SERVICE BULLETIN

TS-930S Low RX Sensitivity

3.29.83

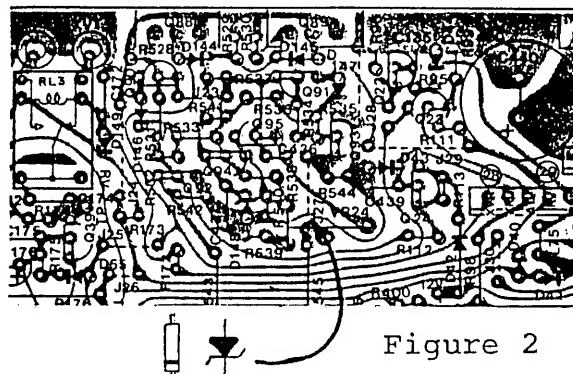
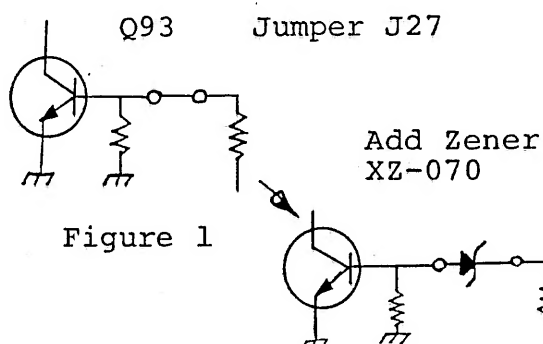
1. Replace Signal unit jumper J27 with an XZ-070 zener diode. (PCB coordinate C-1, see figure 2.)

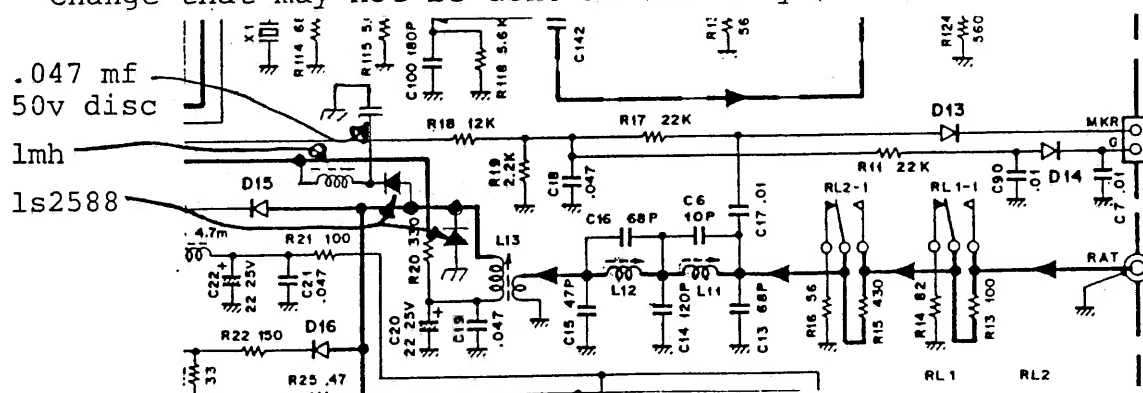
2. Change diodes D15 through D33 from BA282's to 1s2588's. Change only the defective diodes when making the repair.
3. Figure 3 shows a circuit that is capable of withstanding antenna input levels of up to 50 Watts. Use this on units that may be subject to high levels of RF. (This is an optional change that may not be done in warranty.)
